To: All Bidders furnishing labor and materials for:  
**KANSAS COLISEUM BUILDING IMPROVEMENTS**

From: Wilson Darnell Mann P.A.  
105 North Washington  
Wichita, Kansas 67202

### **ADDENDUM #3**

REVISED SECTION 7-EA-S4.1  
 REVISED SECTION 5-T-S3.1

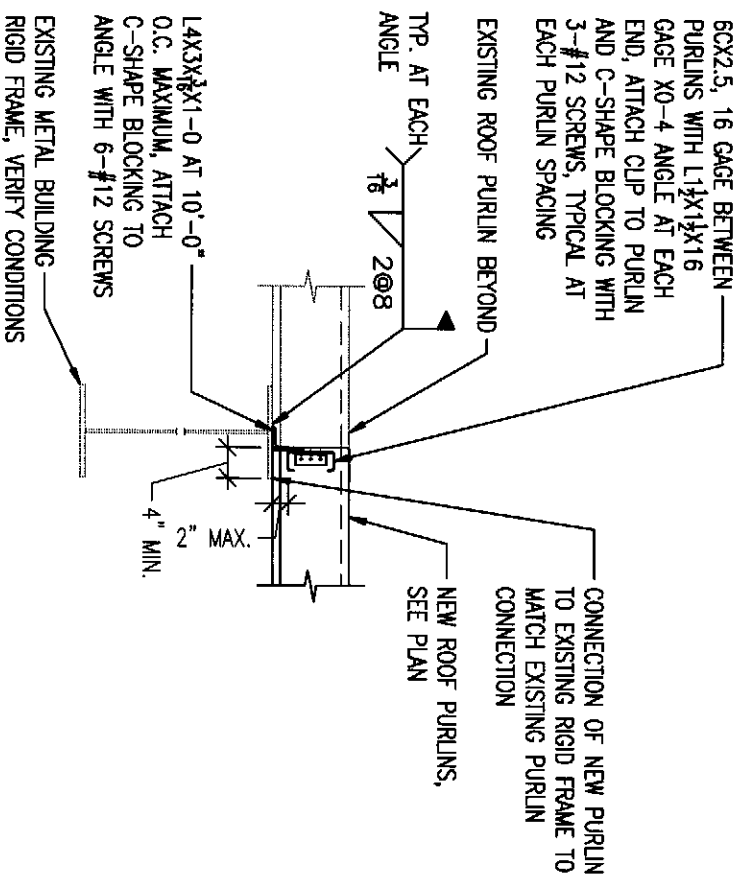
3. Attached is a revised structural detail for 7/EA-S4.1 and 5/T-S3.1.
